Intel® Desktop Board D865GVHZ Specification Update

Release Date: December 2004

Order Number: C59430-008

Figure 23a. Omnidirectional Airflow Heatsink

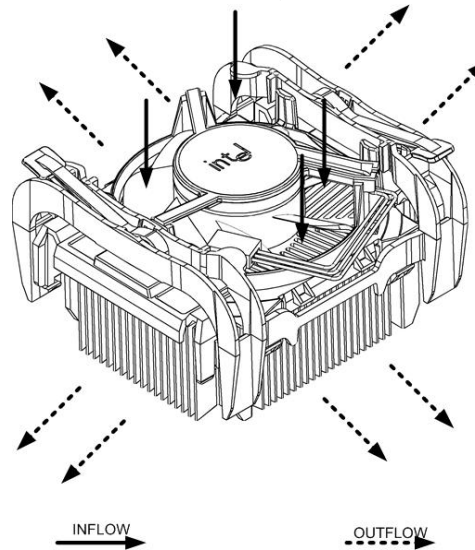
3. **Change to Thermal Considerations, Section 2.12**

Section 2.12, Thermal Considerations will change in its entirety as follows:

The use of an Intel Pentium 4 processor with 1 MB of L2 cache on this Intel desktop board requires the following:

- A chassis with a maximum internal ambient temperature of 38 Degrees Celsius
- A processor heatsink that provides omnidirectional airflow so that air is drawn across the processor voltage regulator area (item A in Figure 24). Figure 23a illustrates an omnidirectional airflow heatsink.

Figure 24. Localized High Temperature Zones

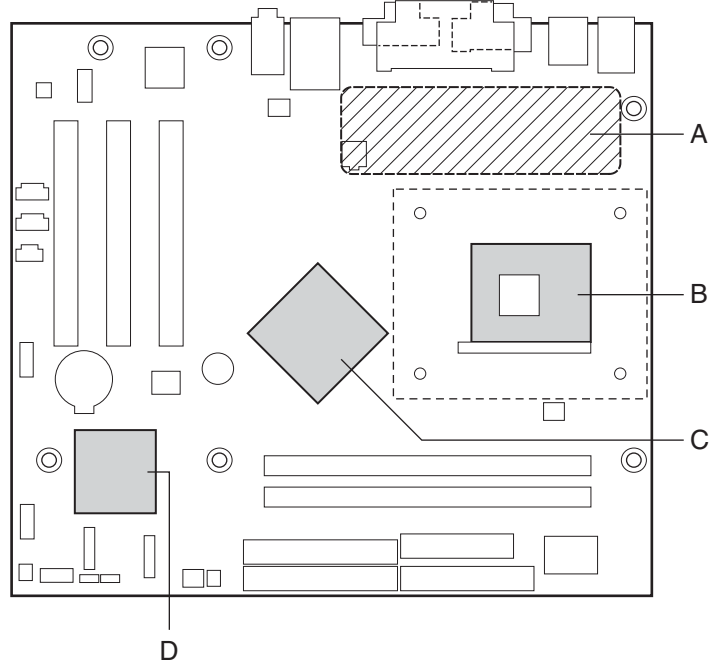
Ensure that proper airflow is maintained in the processor voltage regulator circuit. Failure to do so may result in damage to the voltage regulator circuit. The processor voltage regulator area (item A in Figure 24) can reach a temperature of up to 85 °C in an open chassis.

Figure 24 shows the locations of the localized high temperature zones.
